AMENDMENTS TO THE DRAWINGS

REMARKS

This is intended as a full and complete response to the Office Action dated February 19, 2009, having a shortened statutory period for response set to expire on May 19, 2009. Please reconsider the claims pending in the application for reasons discussed below.

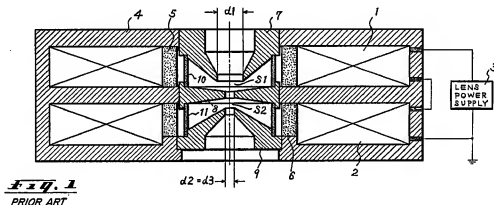
Tsuno teaches an electron lens, equipped with three magnetic pole pieces defining two gaps forming two magnetic fields of opposite polarity. Figure 1 shows an electron lens, as depicted below. The Examiner asserts that spacers 10 and 11 correspond to the distance pieces and the yoke 4 corresponds to the holding piece of the present application. (Office Action dated Feb. 19, 2009, p. 4.) Applicants respectfully disagree.

However, *Tsuno* fails to teach, show, or suggest, a first holding piece directly fastened to a first distance piece, as recited in claims 1 and 19. The Examiner acknowledges this fact by asserting that a holding piece can be attached to another distance piece through one or more other pieces. (Office Action dated Feb. 19, 2009,

In the electron lens of *Tsuno*, an upper pole piece 7, a middle pole piece 8 and a lower pole piece 9 are installed with non-ferromagnetic spacers 10 and 11 therebetween. (*Tsuno*, 1:19-30.) The pole pieces are enveloped by a ferromagnetic yoke 4. (*Id.*)

pages 4-5.) Thus, *Tsuno* fails to teach or describe each and every element arranged or combined in the same way as in independent claims 1 and 19.

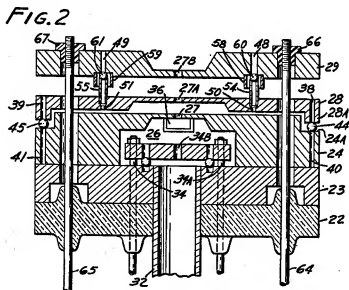
Robinson discloses an arrangement for vacuum electrodes. Referring to Figure 2, shown below, the Examiner states that tie rods 64, 65 correspond to holding pieces that are attached to the first distance piece. (Office Action dated Feb. 19, 2009, pages 5.)

The Examiner notes that the tie rods 64, 65 are attached to the spacing balls 60, 61 through electrodes 28, 29 (corresponding to the first and second element). (Office Action dated Feb. 19, 2009, pages 5.)

However, *Robinson* fails to teach, show, or suggest, a first holding piece directly fastened to a first distance piece, as recited in claims 1 and 8. The Examiner again acknowledges this fact by asserting that a holding piece can be attached to another

distance piece through one or more other pieces. (Office Action dated Feb. 19, 2009, pages 4-5.) Thus, *Robinson* fails to teach or describe each and every element arranged or combined in the same way as in independent claims 1 and 8.
